KIDDERPORE AVENUE · HAMPSTEAD

PROPOSED AMENDMENT TO ROOF WORKS TO MAYNARD WING

Extract from 9000-DRG-00GN-DE016 T1

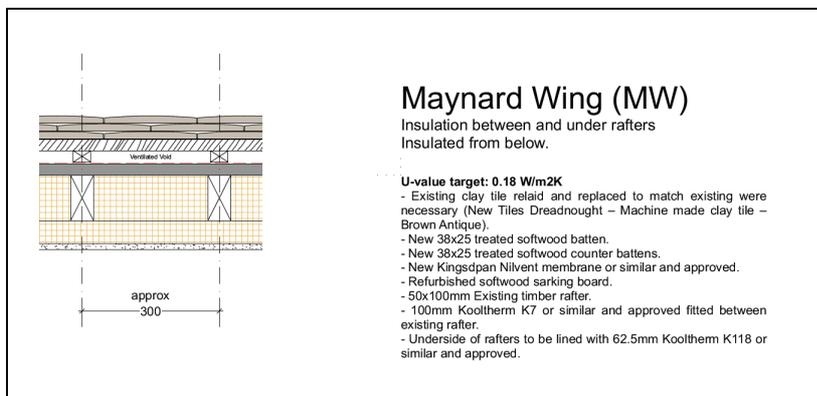
It has been found that the existing sarking boards are firmly fixed with large head nails, which when removed are likely to split the existing rafters and severely damage the boards, prompting renewal.

Since the preparation of DE016 T1, the investigations and subsequent necessary actions to remove asbestos has resulted in the removal of nearly all ceiling plaster. Small areas remain to the underside of the existing rafters. This will, in any event, be reduced further for the fire and acoustic separation works required for party walls, together with structural remedial works and the additional supports necessary for the clock tower.

In order to maintain the integrity of the existing roof structure and preserve more of the historic fabric, it is proposed to vary the methodology to insulate from below, by removing what little remains of the existing plaster, leaving the sarking boards intact.

Amended proposed detail to be finished with plasterboard lining to skelings.
